# ATTACHMENT D

## DEPARTMENT OF TRANSPORTATION

RE: Preliminary Plan Letter  
Preliminary Plan No. 12017015A  
Bloom Montgomery Village

RE: Preliminary Plan & Design Exception Letter  
Preliminary Plan No. 120170150  
Bloom Montgomery Village

**Micromobility Corrals:**

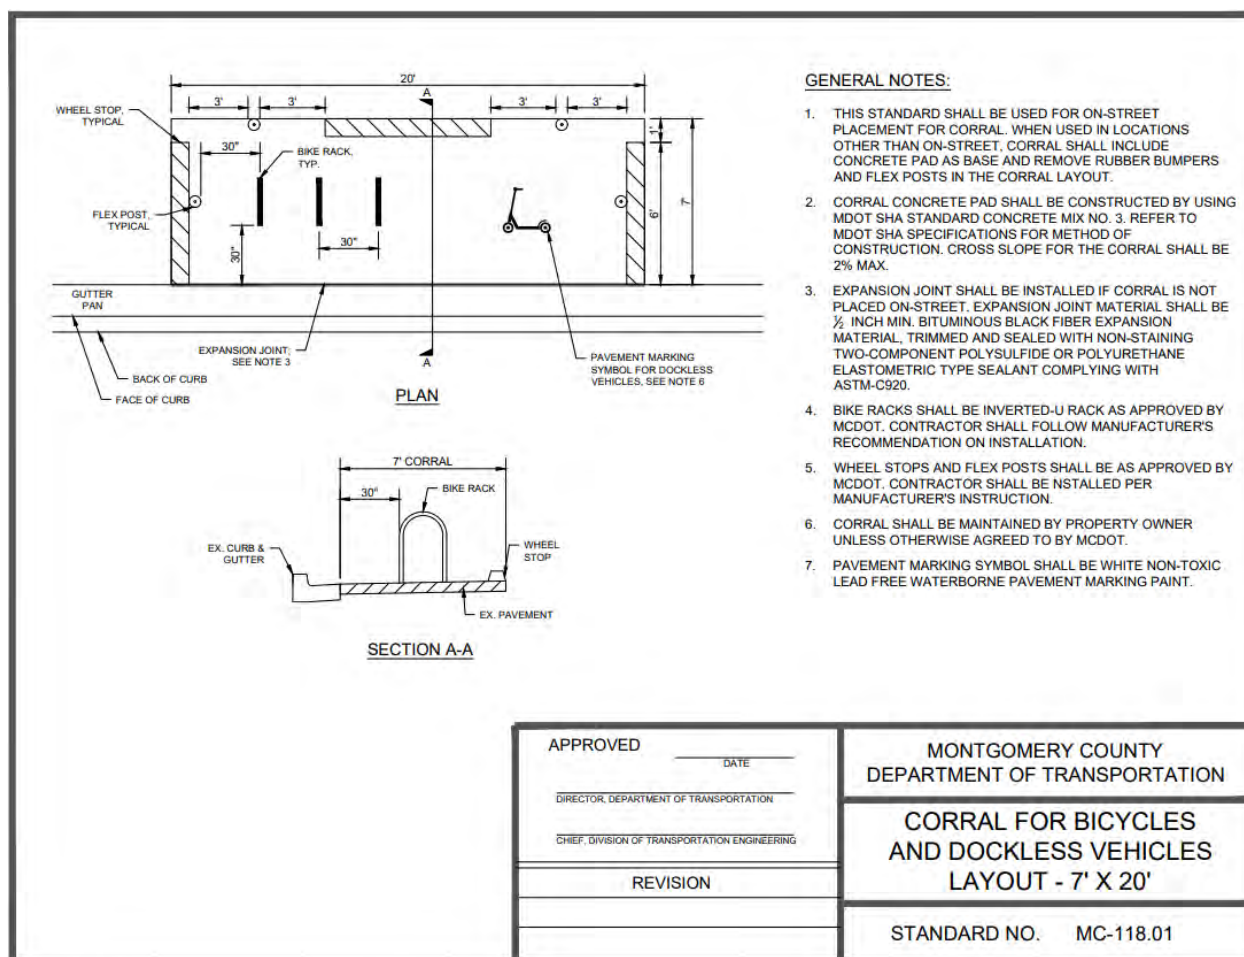
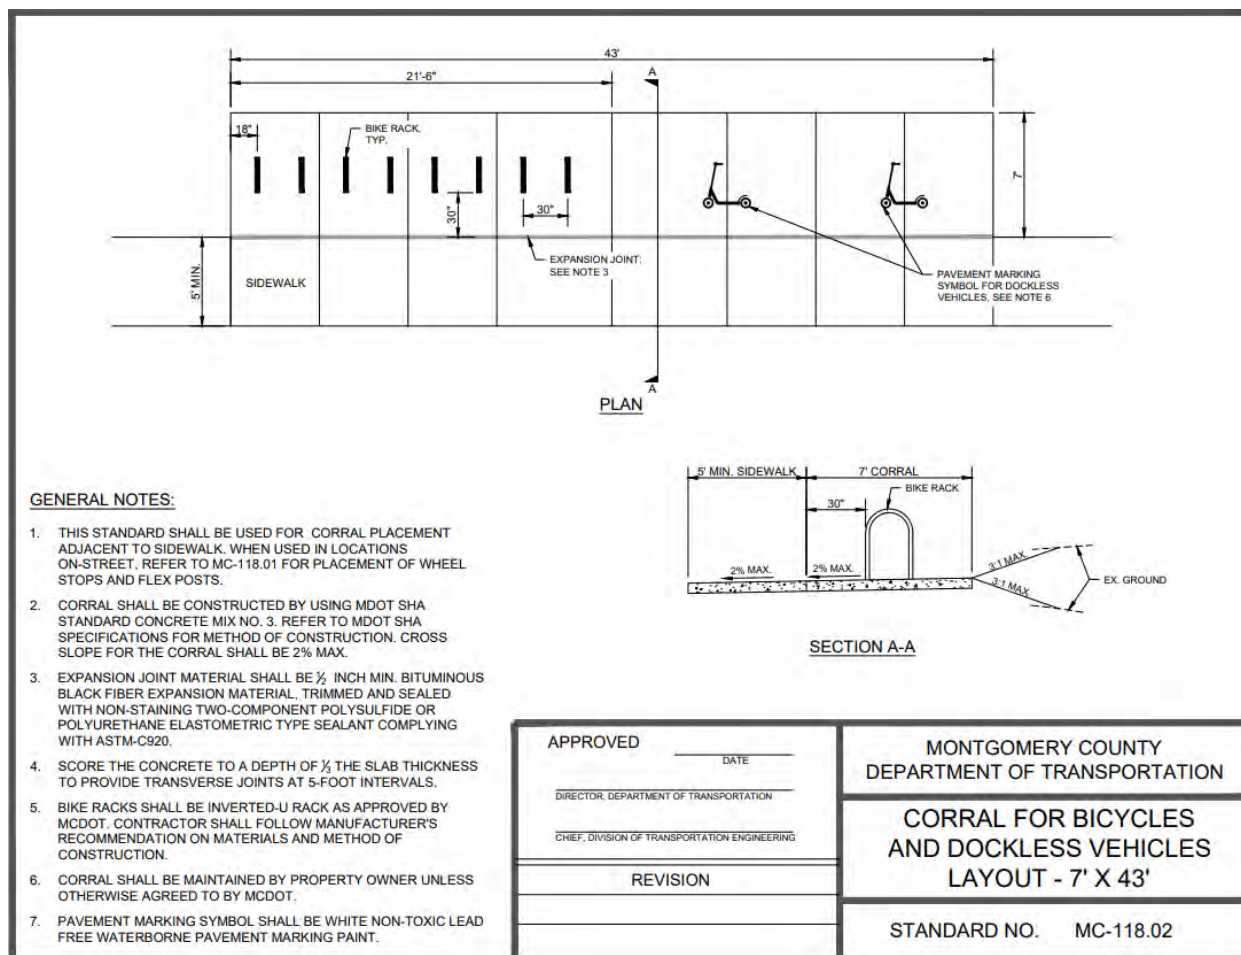
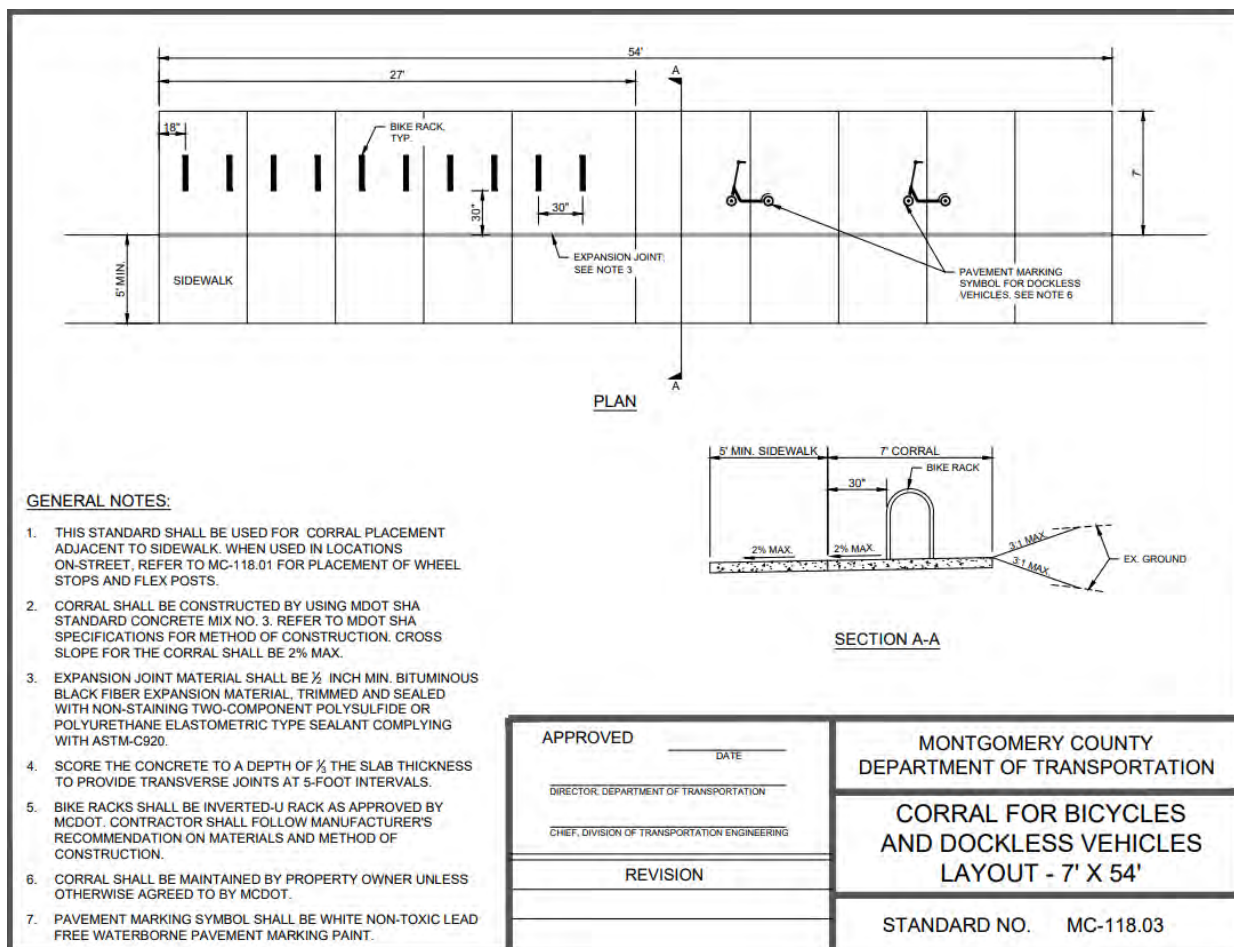
The previous preliminary plan approval required space for 2 bikeshare docking stations. One was to be located at the MVF park in Area I and one in Area IV. CSS identified one location shown in Area I/Parcel E on Detailed Site Plan Area 1 (#829170130, SP-07). The second location had not been identified but the recommendation was made that the Area IV site should be located so as to connect Montgomery Village Avenue to destinations along Arrowhead Road (e.g., North Creek Community Center) and Rothbury Drive. Both sites should receive 4 to 6 hours of sunlight per day and meet siting criteria for a 19-dock bikeshare station.

Since the time of that approval, the County's policy regarding bikeshare program expansion has changed. Capital Bikeshare is still in operation region-wide, and the County fully funds the operations of its existing stations; however, the County is not currently expanding the program with additional stations. The current policy is that in space previously required for the installation of a bikeshare station, the developer must pay for and install a micromobility corral. The space must still meet the siting criteria for a bikeshare station in case new station installations are able to resume in the future. Micromobility corrals are designated parking areas for shared-use and privately-owned mobility devices (i.e., personal, or shared e-bikes, e-scooters, etc. plus pedal bikes) that might otherwise become impediments to pedestrian and other movement. The Applicant is required to prepare a concrete pad (54-ft X 7-ft) and provide certain facilities (racks, flexi-posts, bumpers, lighting, etc.) at the two locations previously required by Planning Board approval, albeit not a bikeshare station. We will provide the applicant with information that includes siting criteria for use in identifying the 2nd space and standards for the micromobility corrals. The detail of the corral is attached below.

In cases where a micromobility corral is being installed at a location originally planned or required for a bikeshare station (including those where a concrete pad already has been installed), the options below should be used to determine a minimum size, consistent with the size of the required bikeshare station.

Where corrals are replacing previously required bikeshare stations, conduit must be run to the pad to provide for potential future vehicle charging needs.

Installation of lighting is required to accommodate the 24-hour availability of micromobility services.

## AREA VI FIRE ACCESS PLAN

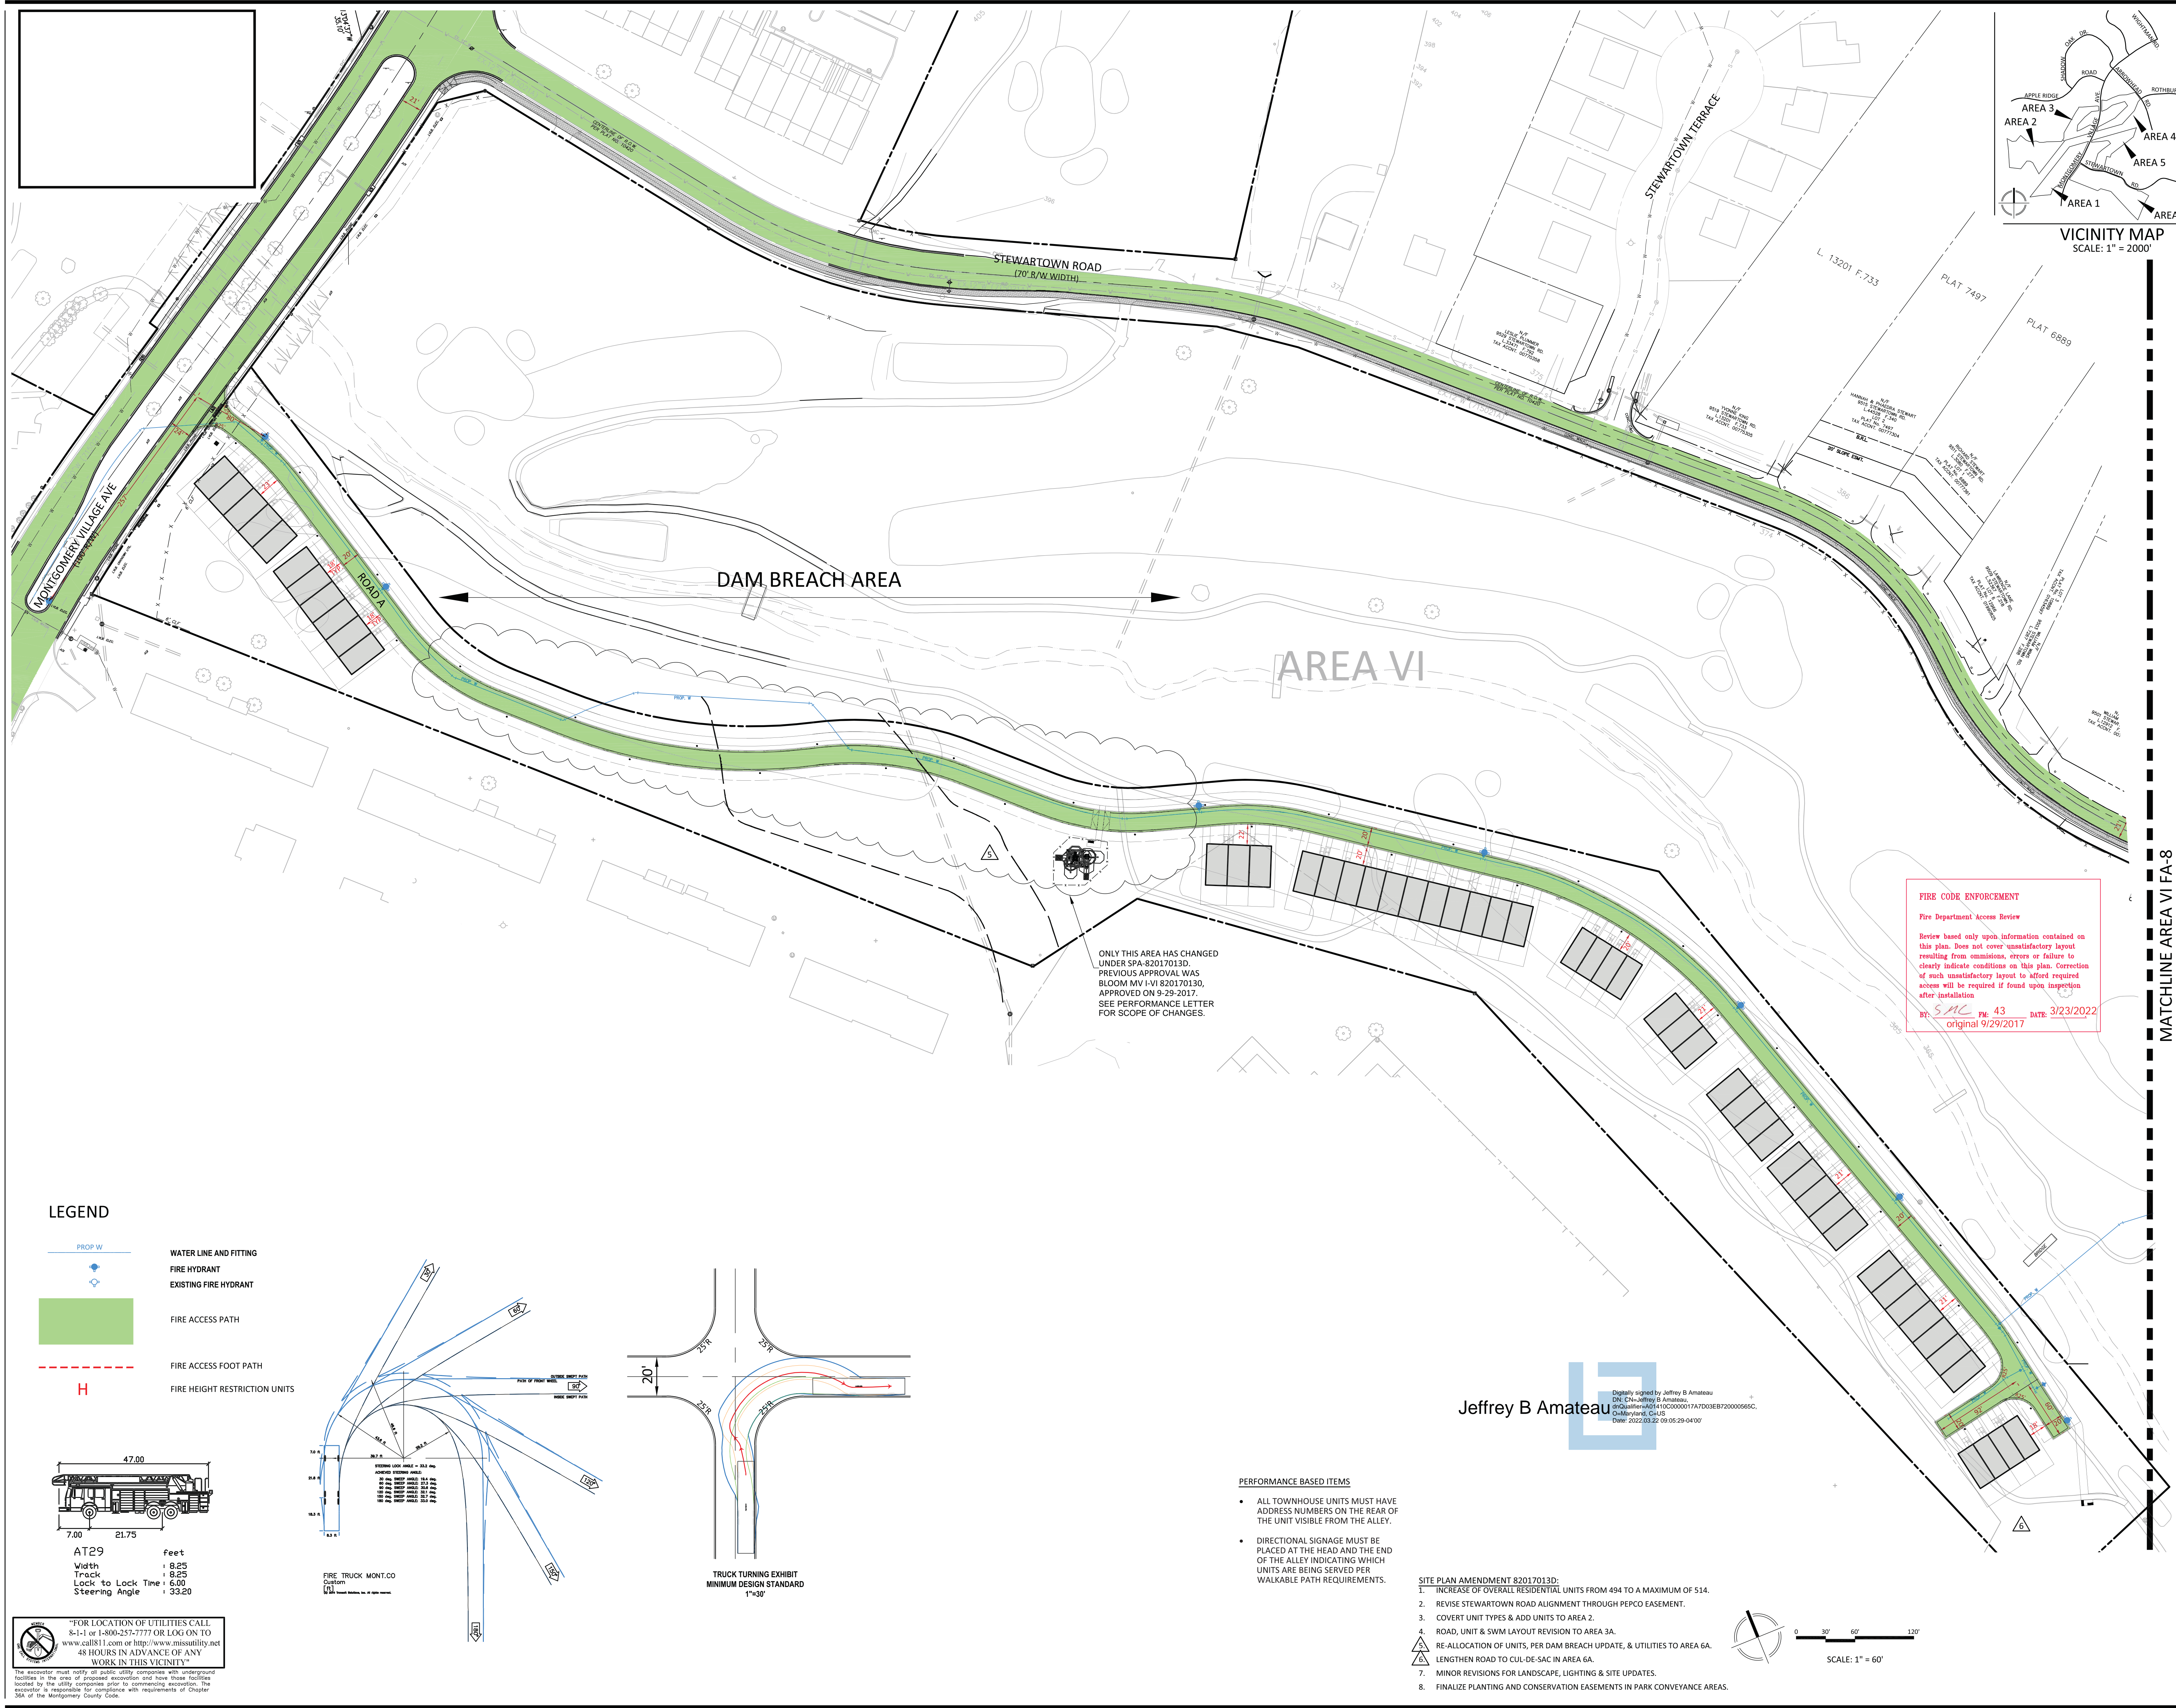
We understand that hydrant spacing is paramount for the safety of a community in the case of a fire event. Because the 500-foot maximum spacing will only be exceeded within the non-buildable dam breach area, while being adhered to within all remaining, buildable areas, the Area 6A design will still meet the fire department's performance needs to best serve this community. The revised changes can be found clouded, on page FAP-6A.
